Modification of Development Consent

Section 4.55(2) of the *Environmental Planning and Assessment Act 1979*

SF21/20014

Modification Application: SSD-5248-Mod-1

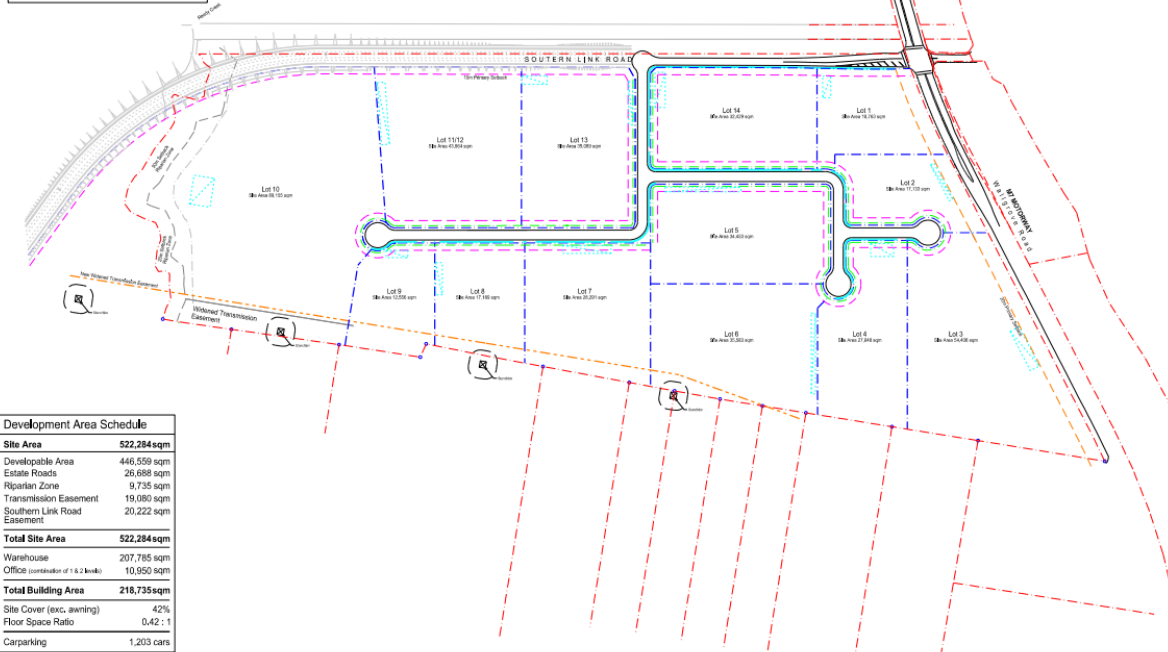
20. Delete Figure 1 and replace with the following:

SBA Momentum M7 - Modification 01 Proposed Development Subdivision Plan
 813-913 Wallgrove Road, Eastern Creek Development Application
 1:2000 @ A1 1:5000 @ A3 MM7 - DA-002(A)
 10 Dec 2020 Job No: 20109

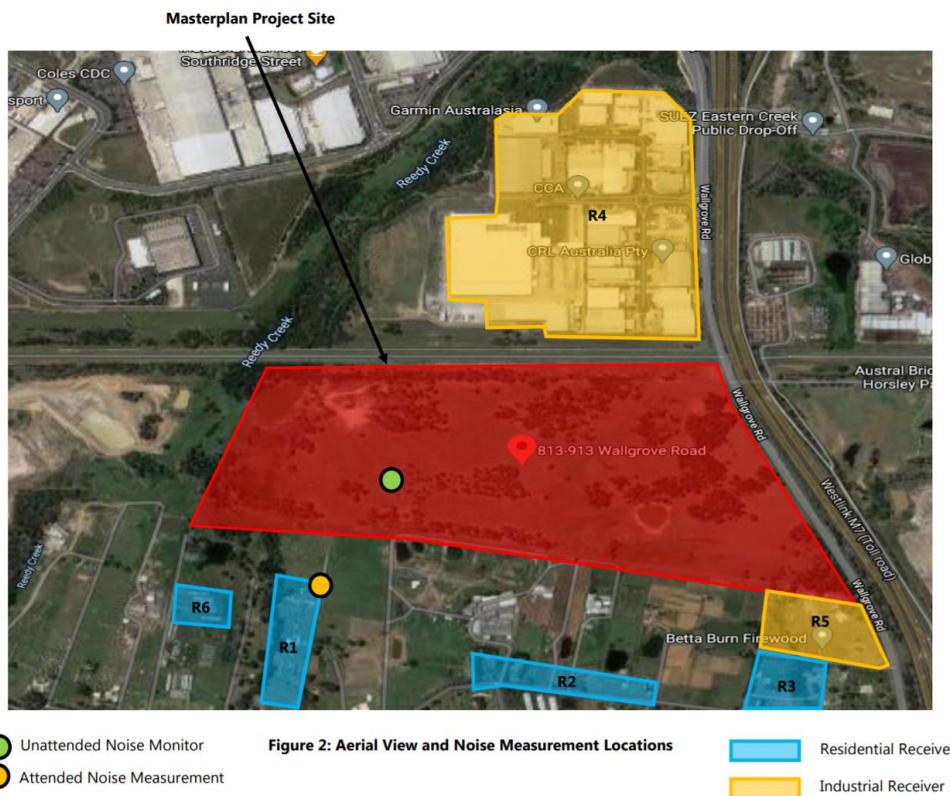
21. Delete Figure 2 and replace with the following:

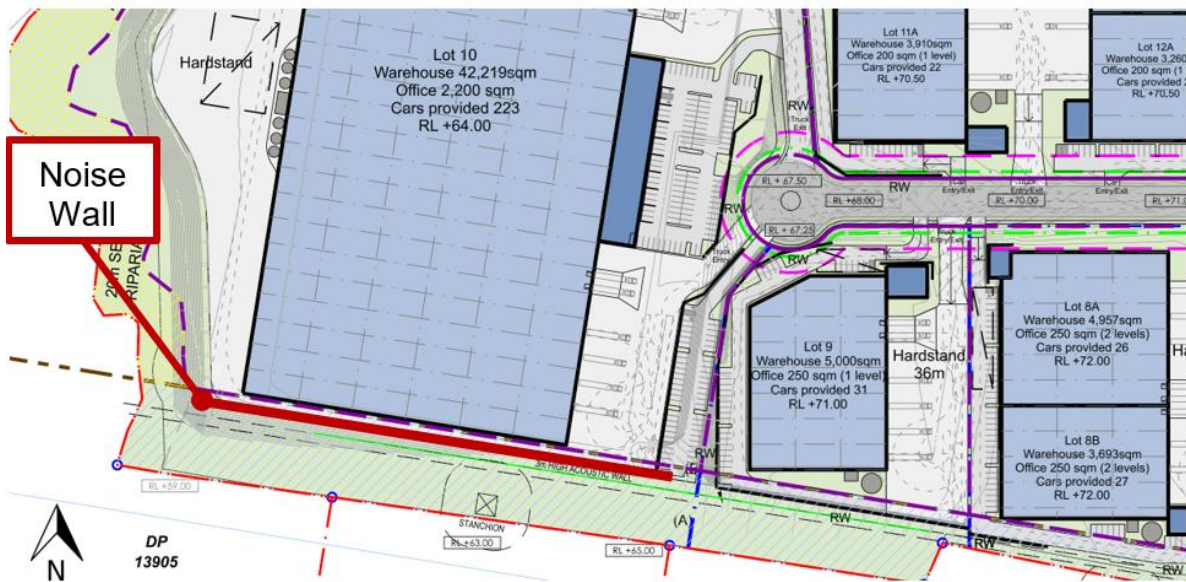
22. Delete Figure 6 and replace with the following:
